PLANNING COMMISSION AGENDA  
CITY OF PRAIRIE VILLAGE  
TUESDAY, SEPTEMBER 1, 2015  
7700 MISSION ROAD  
7:00 P.M.

**TO:** Prairie Village Planning Commission  
**FROM:** Chris Brewster, AICP, Gould Evans, Planning Consultant  
**DATE:** September 1, 2015, Planning Commission Meeting

**Request:** Revised Site Plan Approval to Replace 6 Antenna on Existing Wireless Telecommunications Facility

**Request:** Site Plan Approval in a C-O District for a New Office Building

sheet number  
**A1.1**  
 drawing type  
 planning  
 project number  
 11106

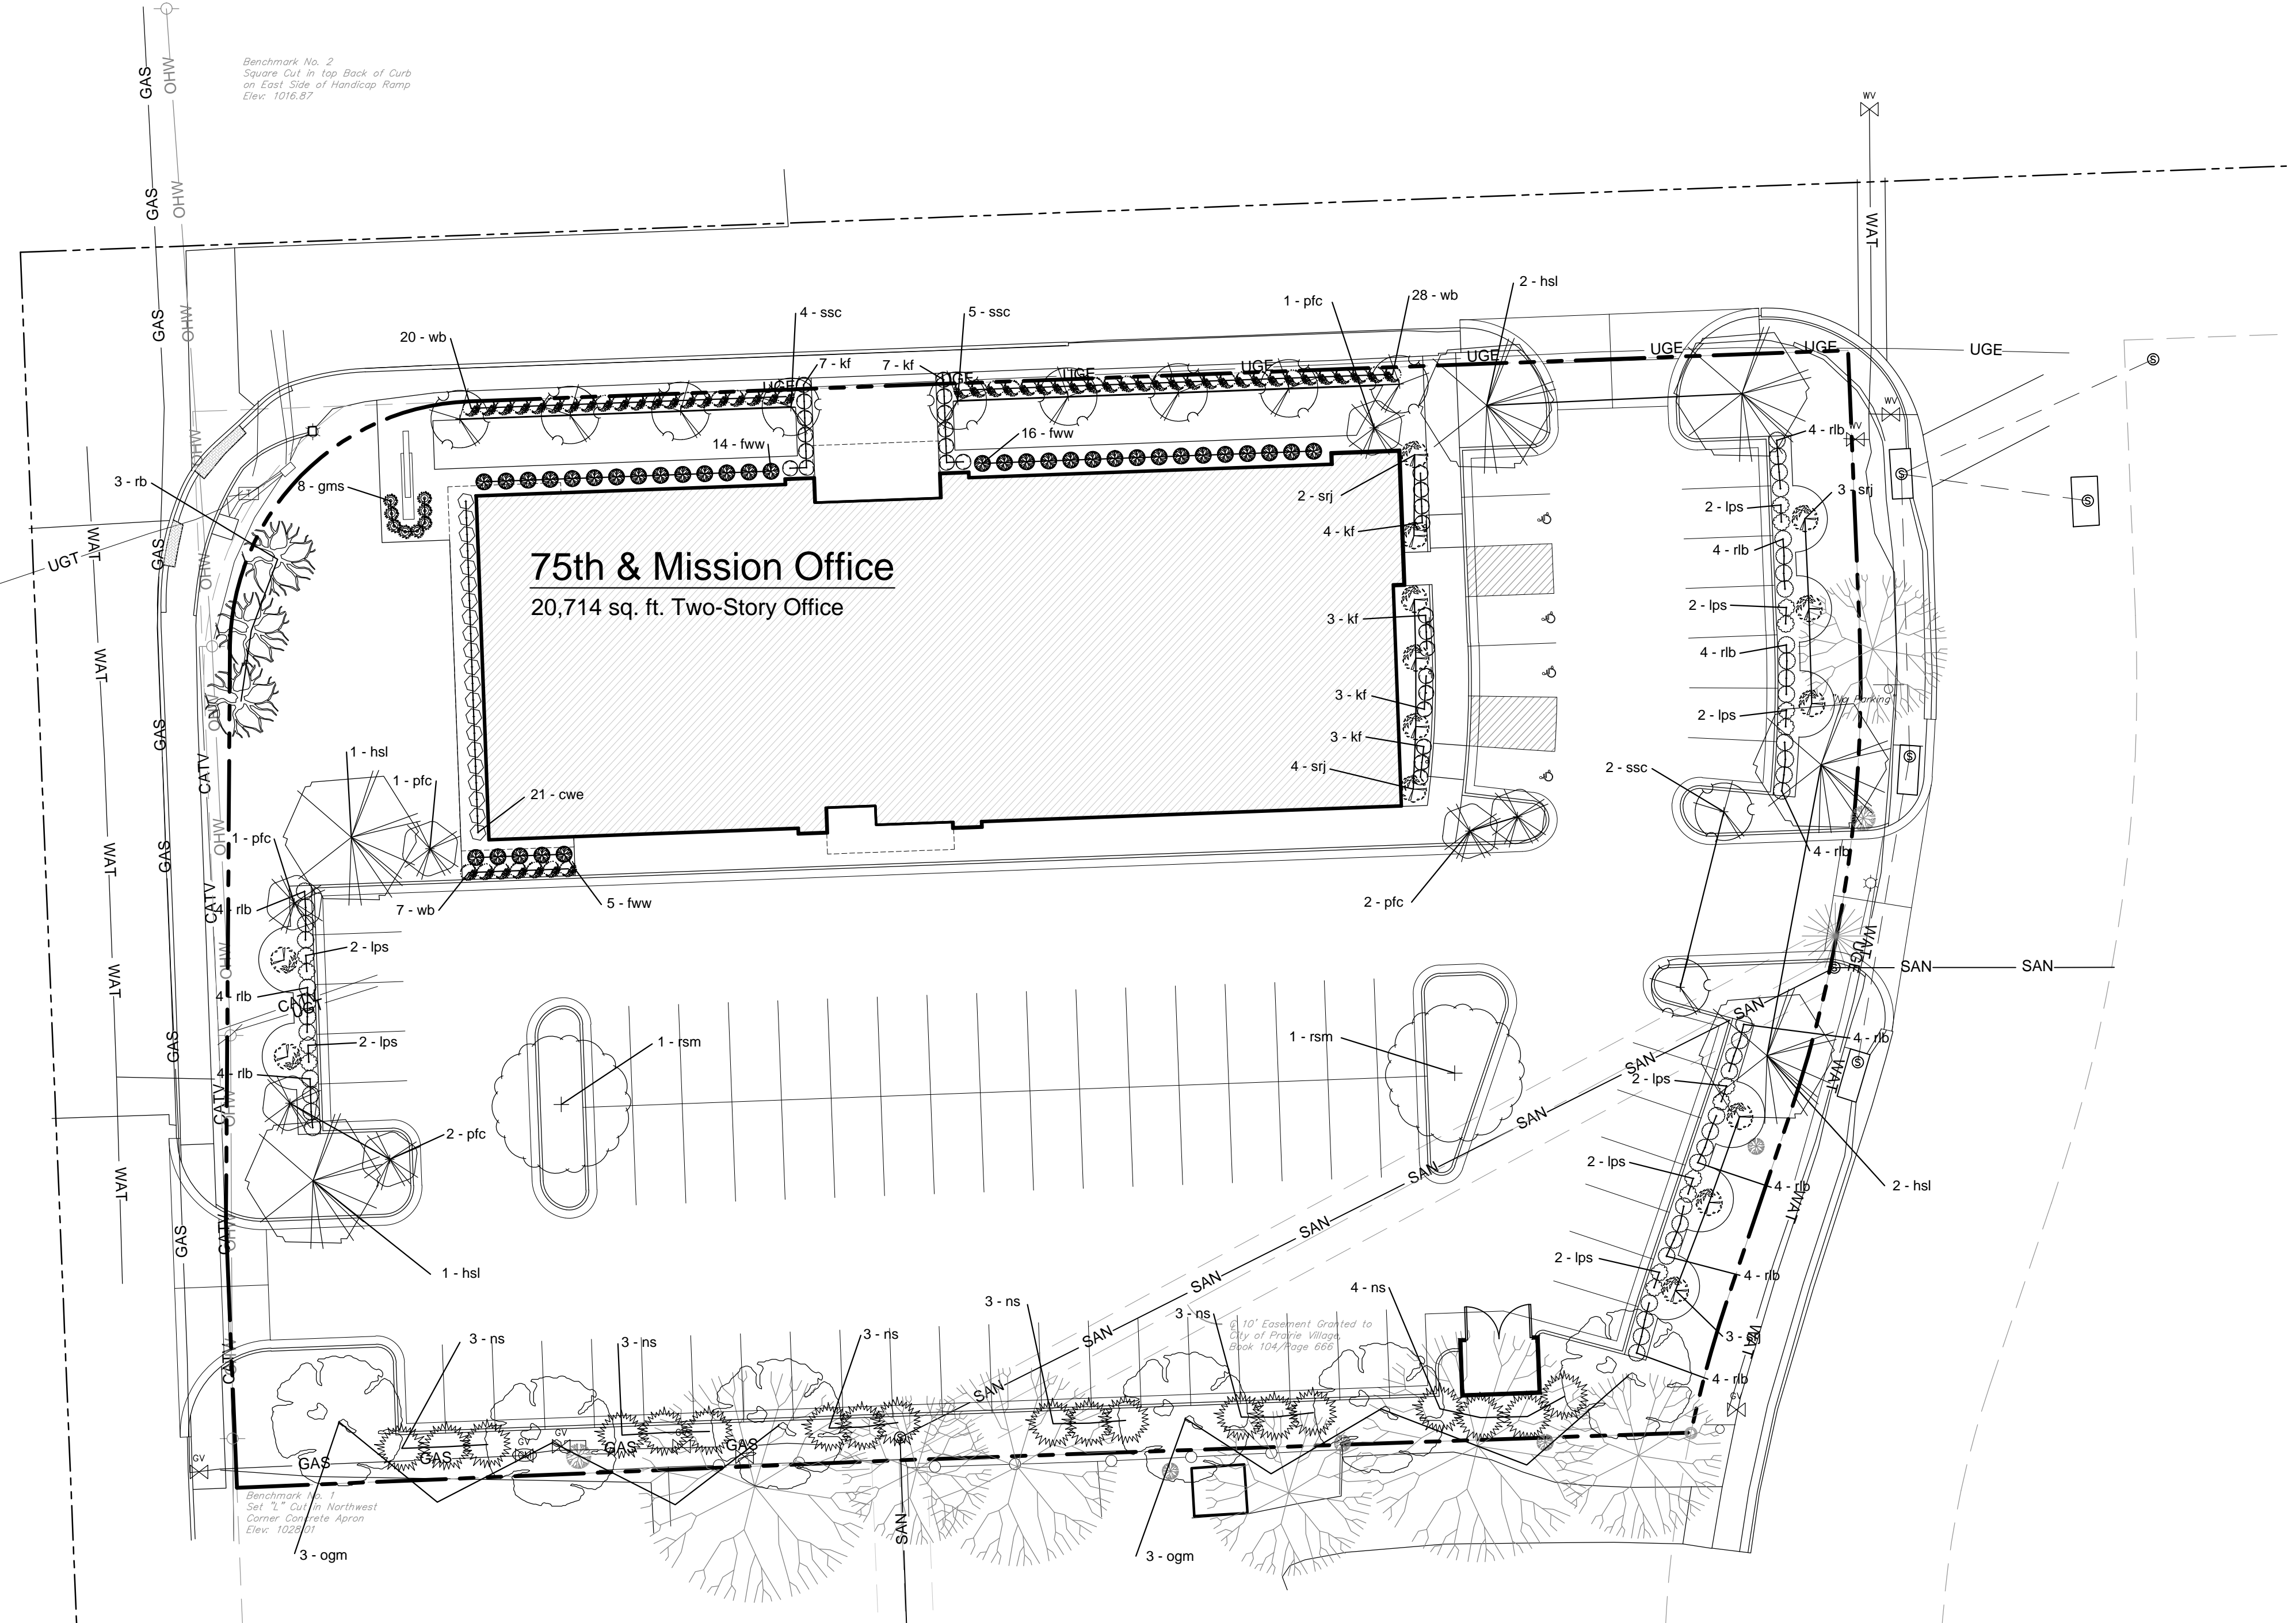
The plan does provide for safe site access, however the need for both of the 75<sup>th</sup> Street access and proposed Mohawk access should be reviewed by Public Works. If access to Mohawk is necessary to improve safety and traffic movements along 75<sup>th</sup> Street, it should be offset from the access on the west side (as depicted in the site plan) in order to discourage cut-through traffic into the neighborhood.

The site plan moves the building closer to the setback lines hiding the majority of the parking to occur behind the building, away from 75<sup>th</sup> Street. This will improve the visual aesthetics of the site and contribute to the overall appearance of the 75<sup>th</sup> Street corridor.

1. A final storm water plan be approved by Public Works.
2. All site design and improvements be coordinated with public improvements for access and streetscape currently under way along 75<sup>th</sup> Street, and access to the site be approved by Public Works.
3. That the landscape plan be revised to include:
  - A. Replace Red Maple trees with White Oak, Swamp White Oak, Kentucky Coffeetree, Autumn Gold Ginkgo or other hardy varieties of large landscape trees.

**1 Landscape Plan**  
scale: 1" = 20'-0"  
north

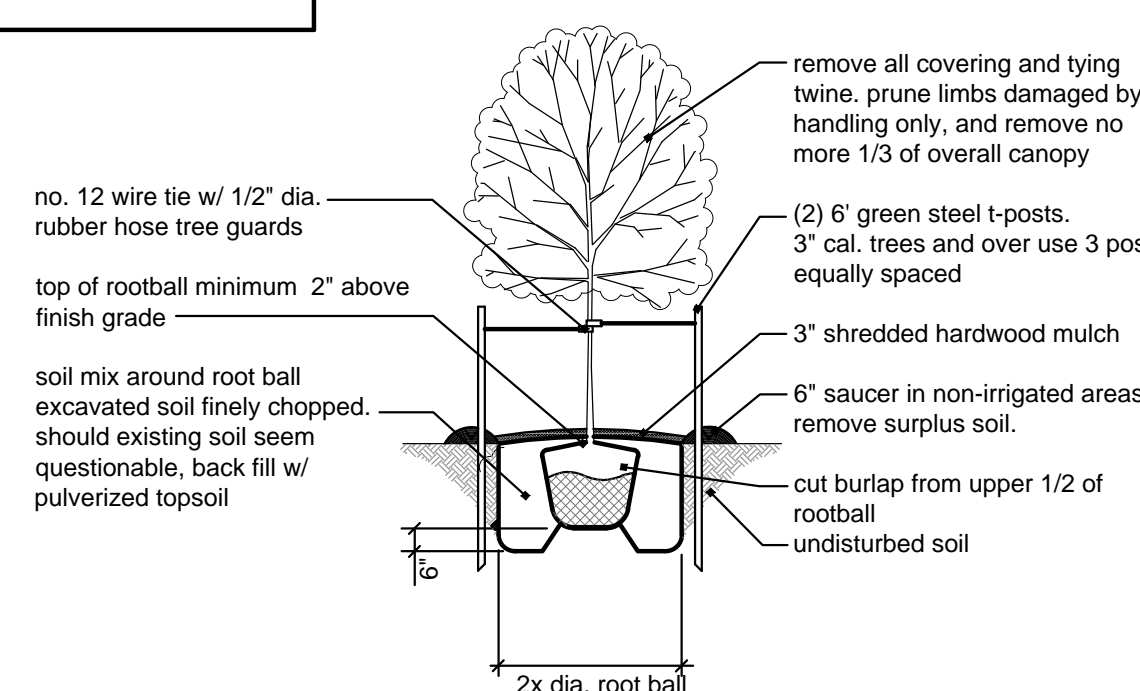
Residential uses to the south are currently buffered from the site through a row of mature trees, on the adjacent property. The landscape plan softens the site by providing adequate landscaping to buffer the parking lot from adjacent properties and accent the building along 75<sup>th</sup> Street and Mission Road. Staff does have a concern regarding some of the species of plant materials selected. Red maples are overplanted in this area and do not perform well over time, needing to be replaced. Appropriate species include White Oak, Swamp White Oak, Kentucky Coffeetree or Autumn Gold Ginkgo. Similarly, the Sunburst cultivar of Honeylocust does not perform well, however other cultivars of Honeylocust, such as Imperial or Streetkeeper perform well and are better for this application. Staff is also concerned about the use of ornamental trees (crabapples are identified) along 75<sup>th</sup> Street. The use of shade trees is more appropriate for this street to provide substantial shade over time for pedestrians and further define the corridor. Hardy street trees such as the Swamp White Oak, Silver Linden, Bald Cypress and Emerald Sunshine Elm are appropriate for situation.

- B. Replace the Sunburst cultivar of Honeylocust identified with either Imperial or Streetkeeper cultivar.
  - C. Replace ornamental street trees along 75<sup>th</sup> Street with appropriate shade trees such as, Swamp White Oak, Silver Linden, Bald Cypress and Emerald Sunshine Elm or other varieties.
-
